Pacific Gas and
Electric Company

PG&E Letter DCL-01-115

Docket No. 50-275, OL-DPR-80
Docket No. 50-323, OL-DPR-82
Diablo Canyon Units 1 and 2
License Amendment Request 01-05
Revision to Technical Specification 1.1, "Definitions, Dose Equivalent I-131," and Revised Steam Generator Tube Rupture and Main Steam Line Break Analyses

REVISED TECHNICAL SPECIFICATION 1.1 THYROID DOSE CONVERSION FACTORS AND REVISED STEAM GENERATOR TUBE RUPTURE AND MAIN STEAM LINE BREAK ANALYSES

Figure 15.4.3-9 Ruptured SG Mass Release Rate to the Atmosphere

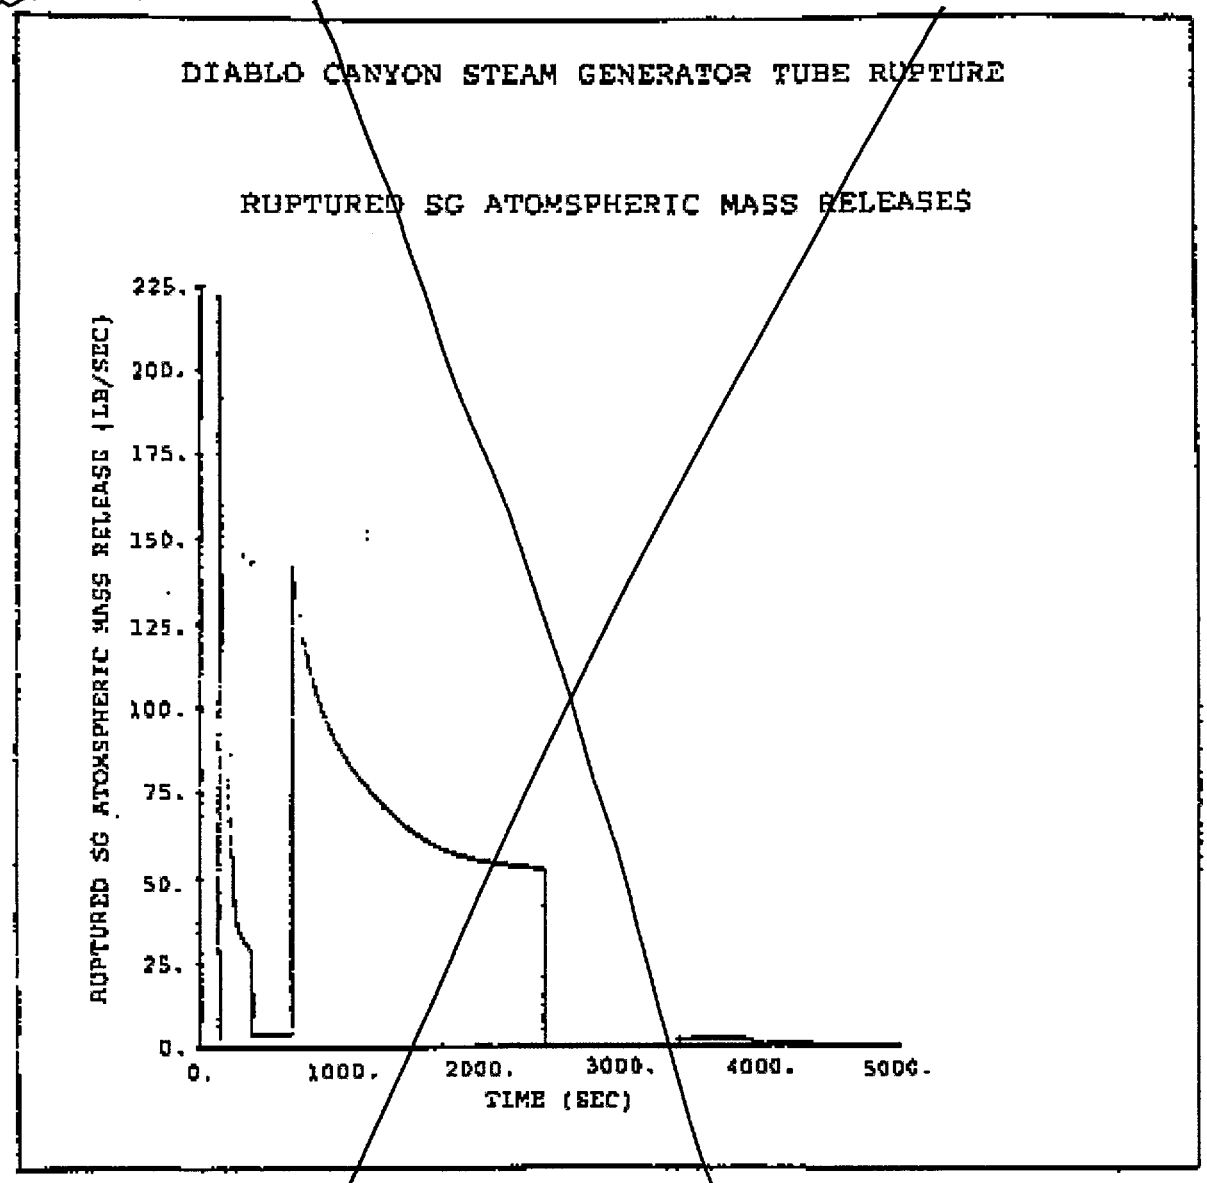
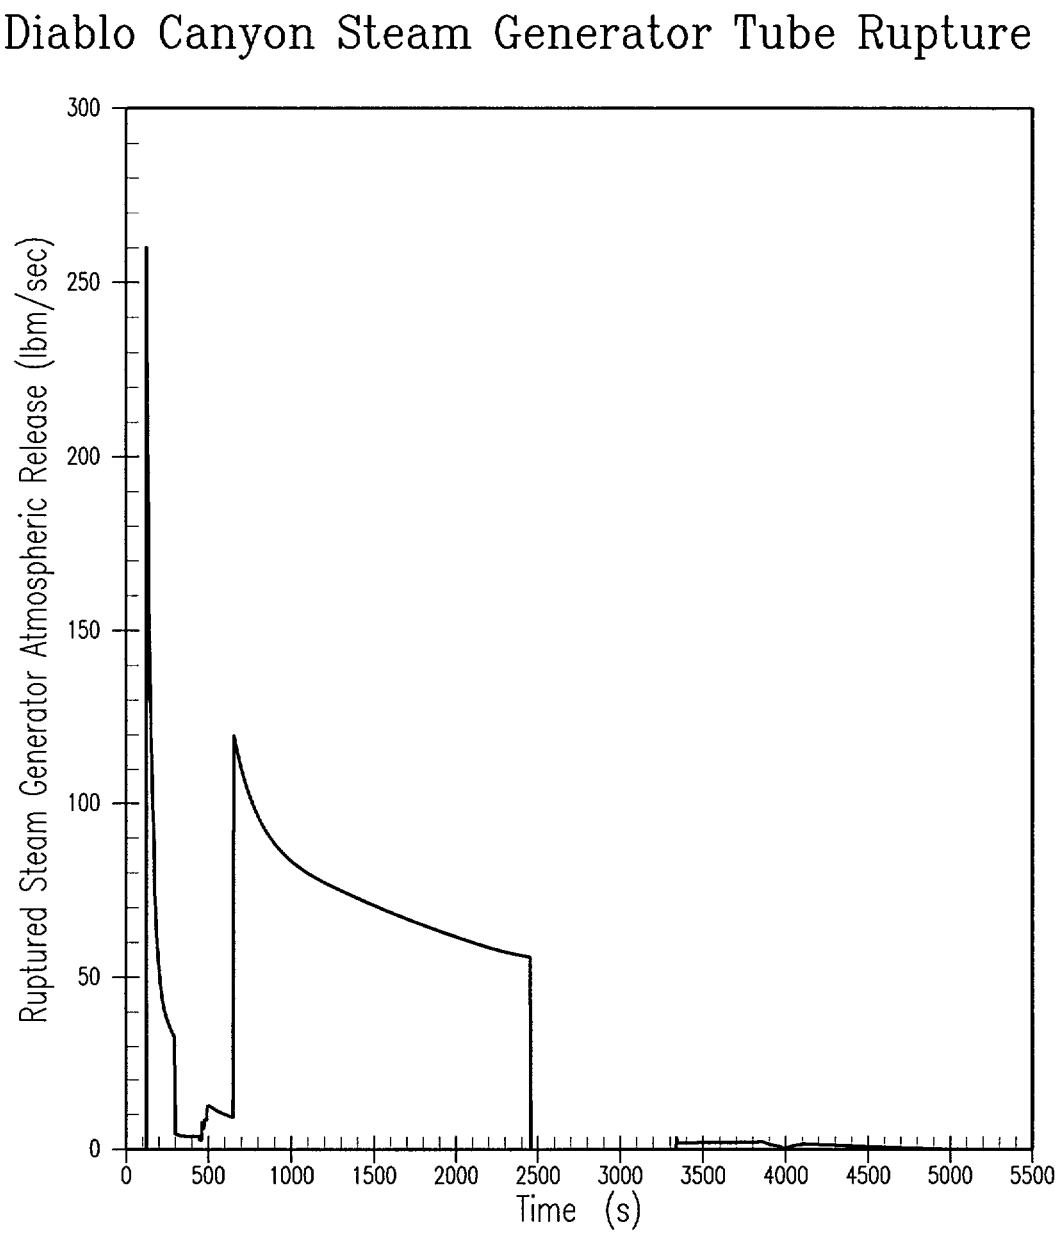
Replace with Figure 15.4.3-9

Figure 15.4-108 Ruptured SG Mass Release Rate to the Atomsphere

Figure 15.4.3-10 Intact SGs Mass Release Rate to the Atmosphere

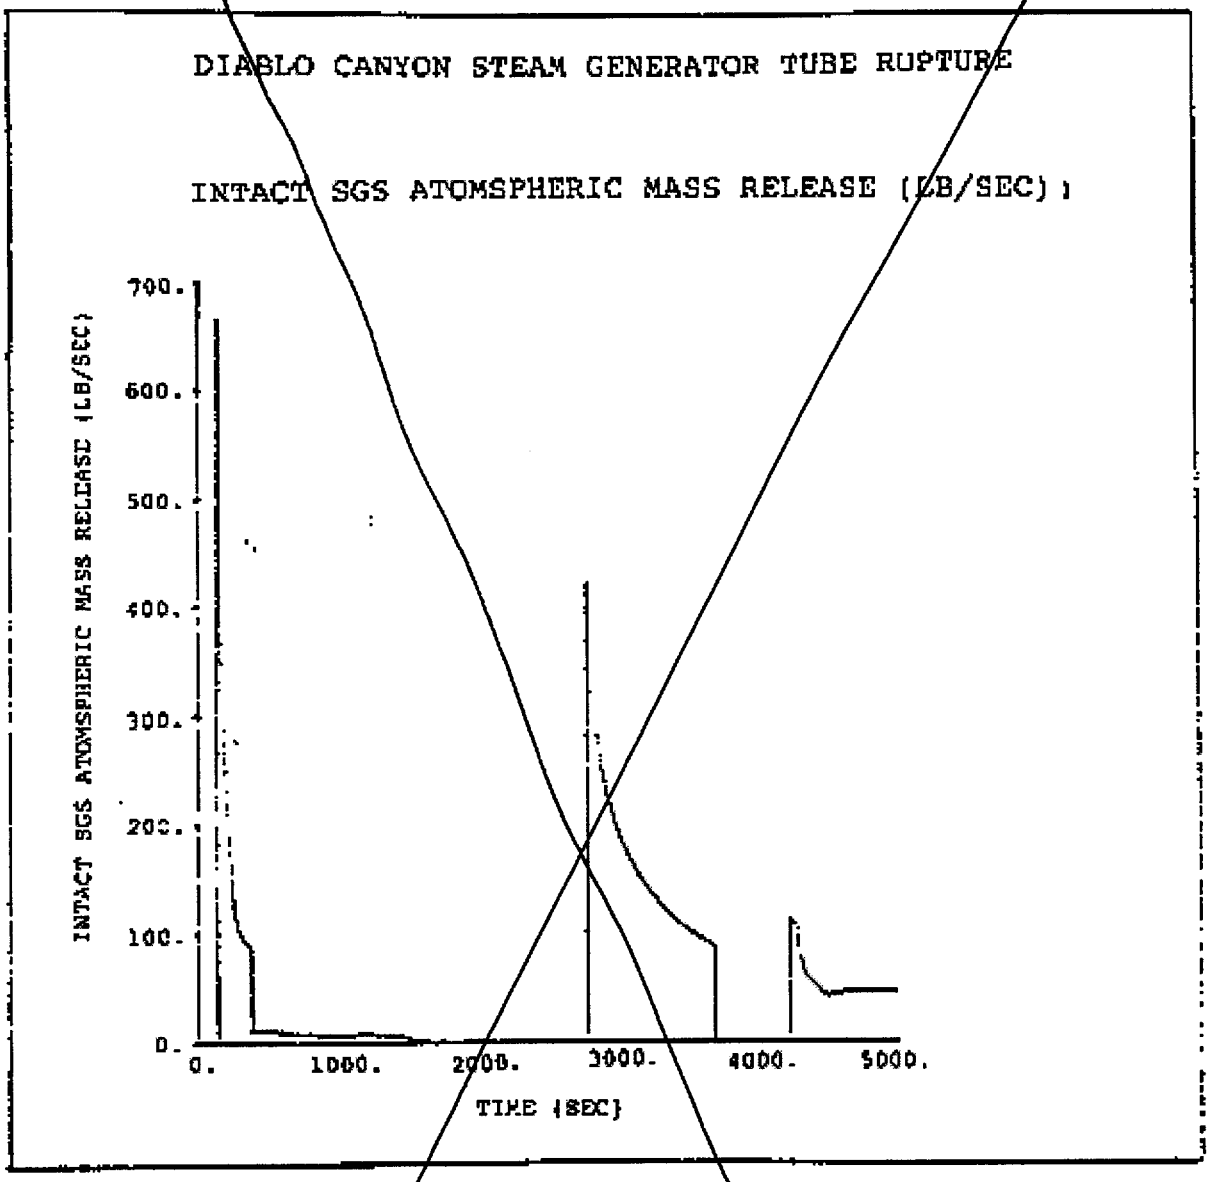
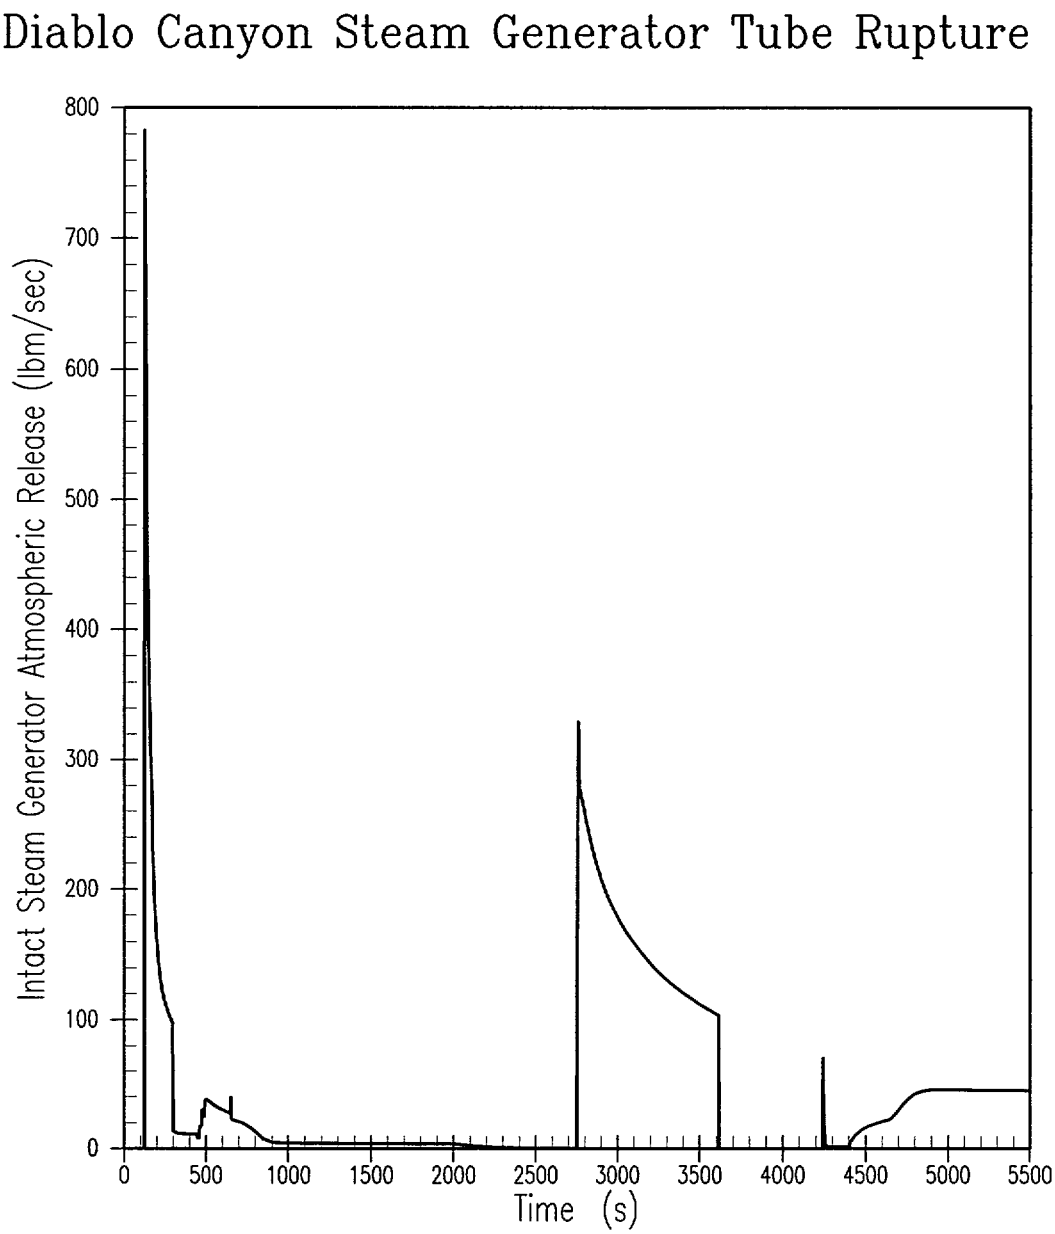
Replace with Figure 15.4.3-10

Figure 15.4-109 Intact SGs Mass Release Rate to the Atomsphere

Figure 15.5-20 Break Flow Flashing Fraction - SGTR Analysis

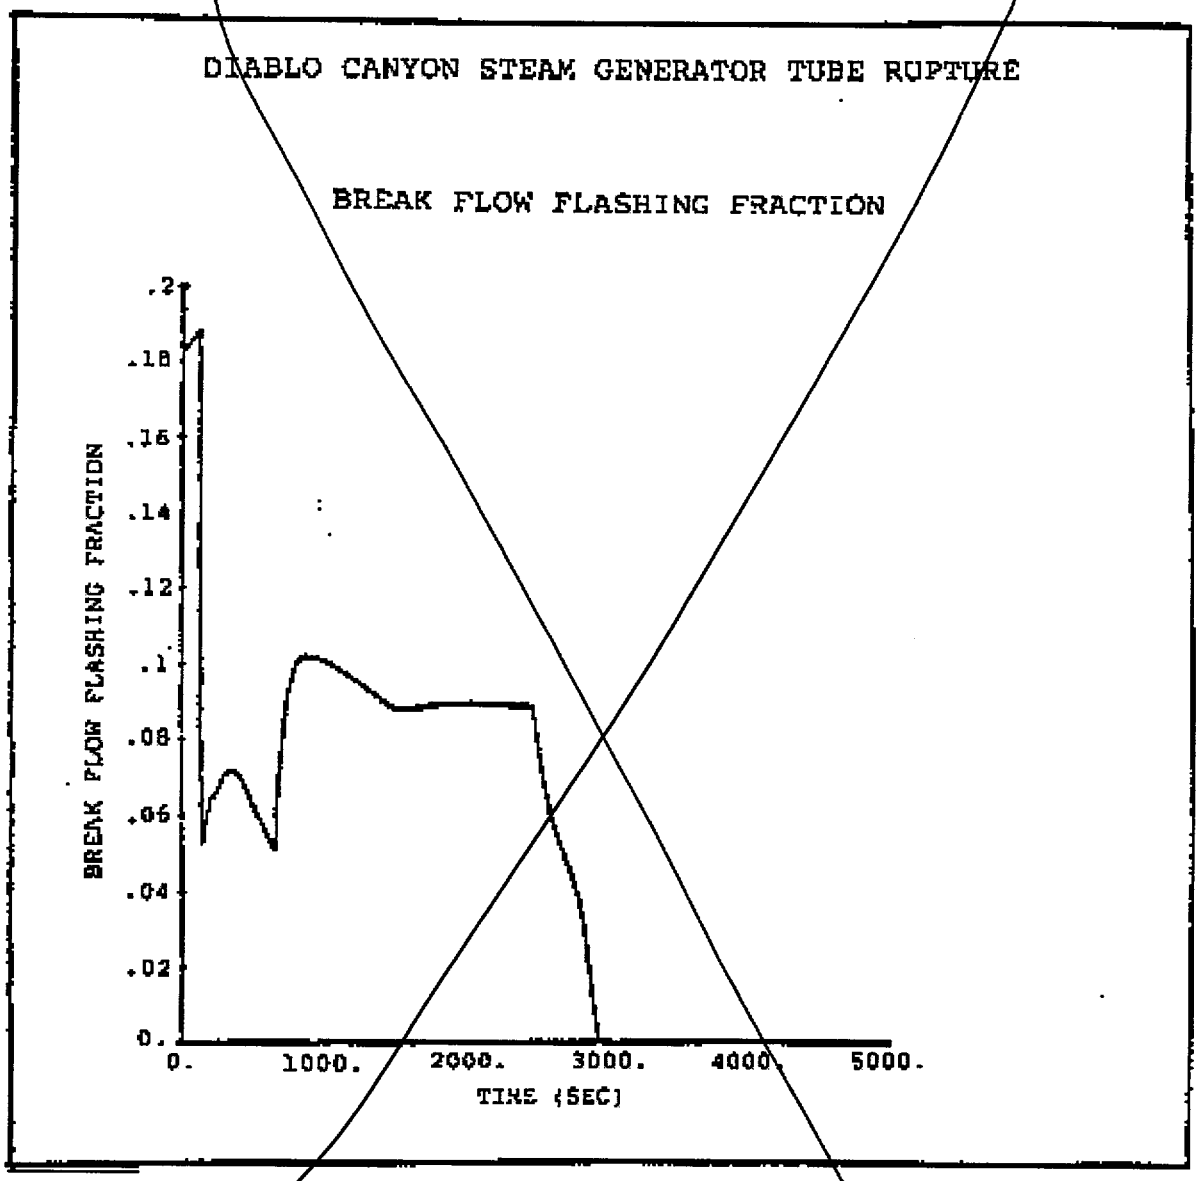
Remove Figure

Figure 15.5-21 SG Water Level Above Top of Tubes - SGTR Analysis

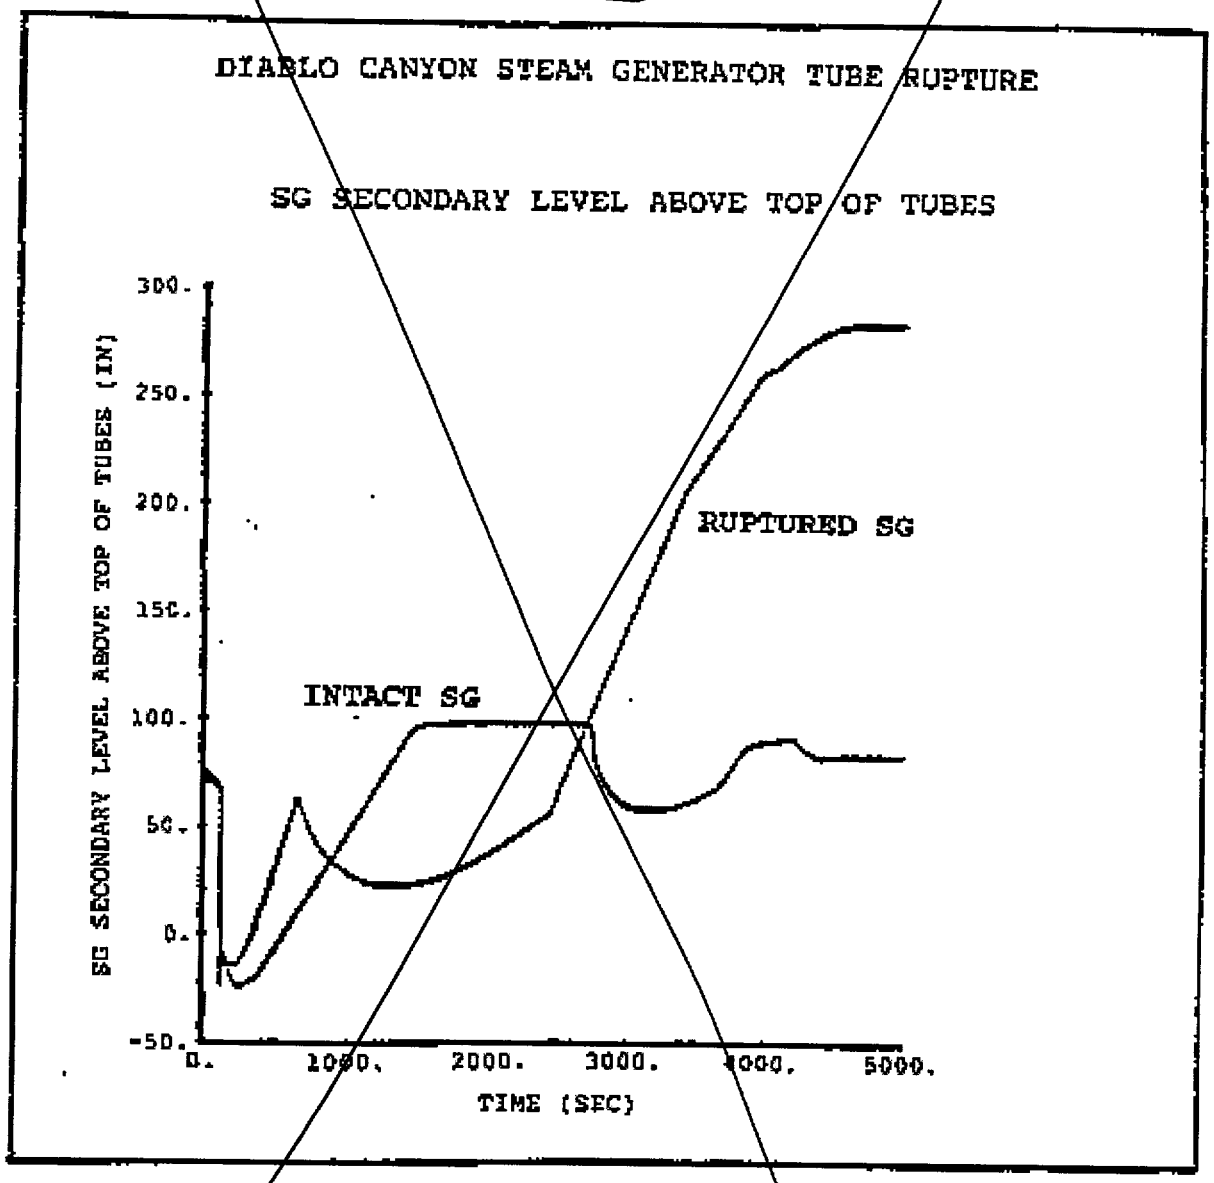
Remove Figure

Figure 15.5-22 Iodine Scrubbing Efficiency - SGTR Analysis

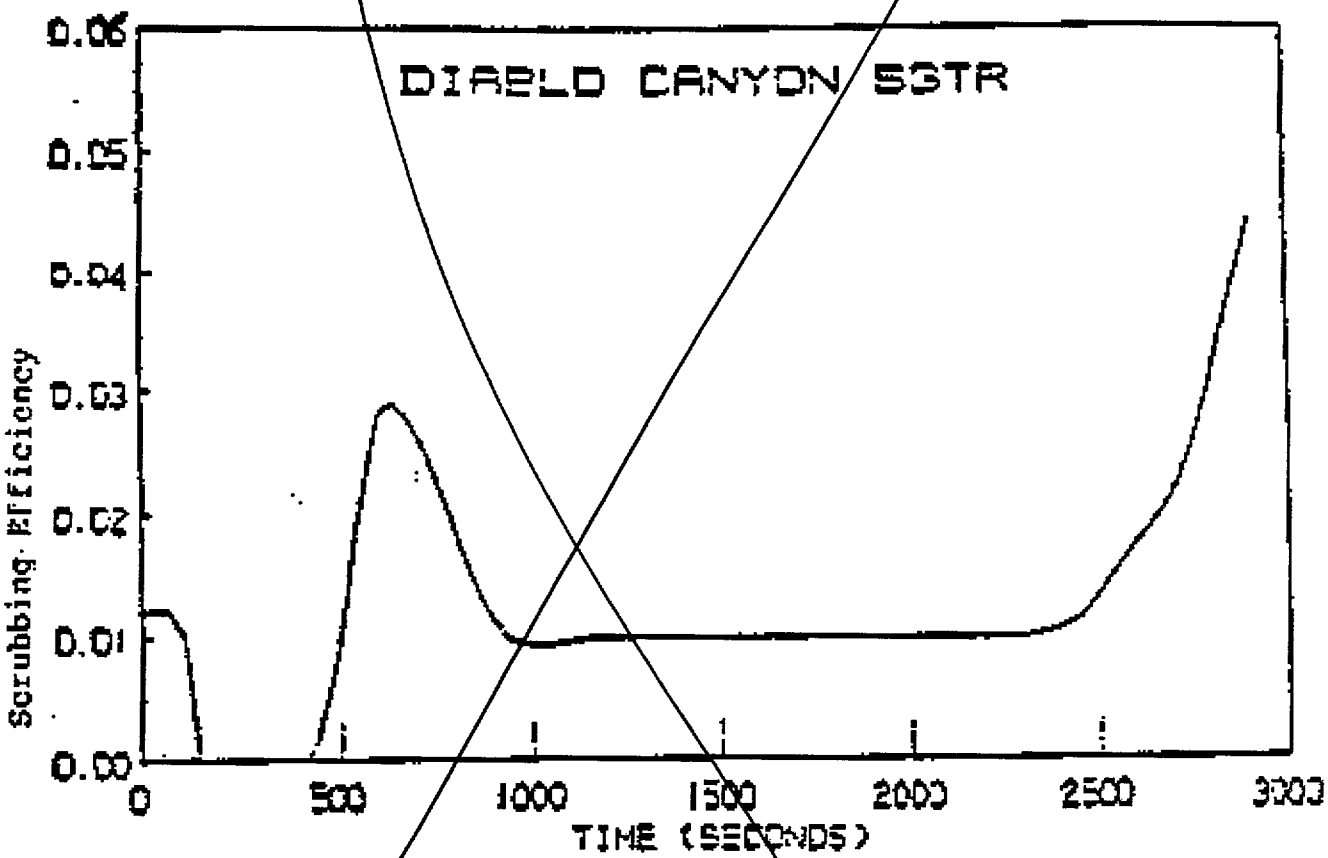
Remove Figure
